Development Variance Permit Presentation

– 884 Lampson Street

DVP – 884 Lampson Street

Purpose and Content of the Variance application

Floor Plan: Parkade P2 – Before & After

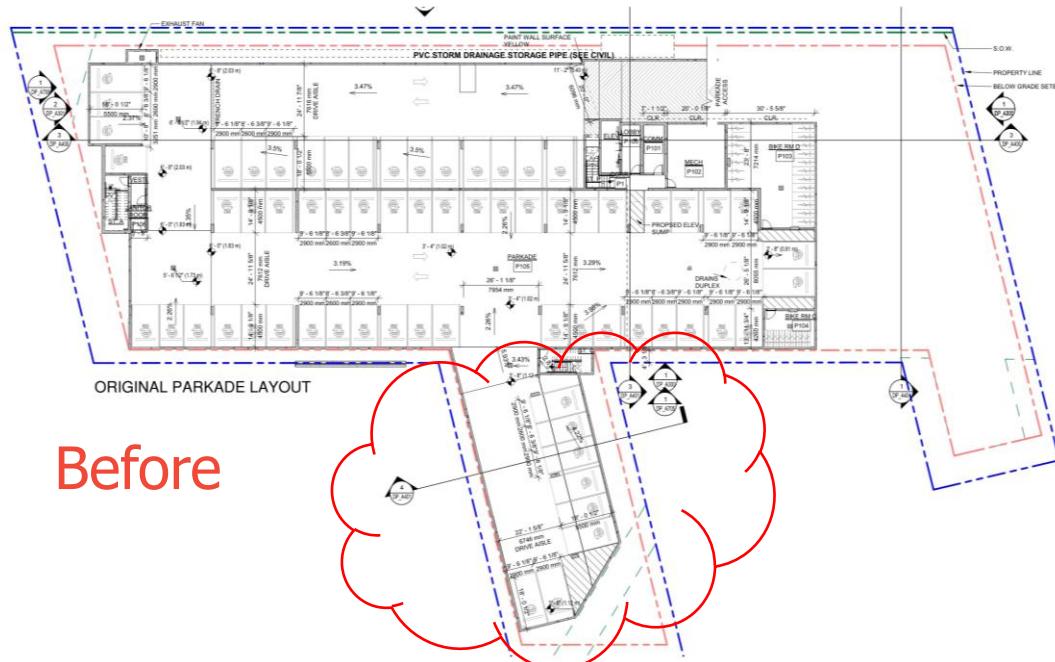
- Original zoning (late 2023) included a parking rate based on the Parking Bylaw of the time
- New Parking Bylaw was adopted in the summer of 2025 which reduced the requirements
- Proposed changes as follows;
 - The new base rate is 95 stalls
 - The provision of one MODO car permits a 5% TDM reduction
 - Increase from 10% to 20% of all required long term bike parking spaces are designed for Oversize Bikes which would permit a 5% TDM reduction
 - New rate is 75 stalls plus 12 visitor stalls for a total of 87 stalls plus 1 MODO stall
 - Reduced parking rate from 0.92 to 0.73 with TDM
- No other changes are proposed
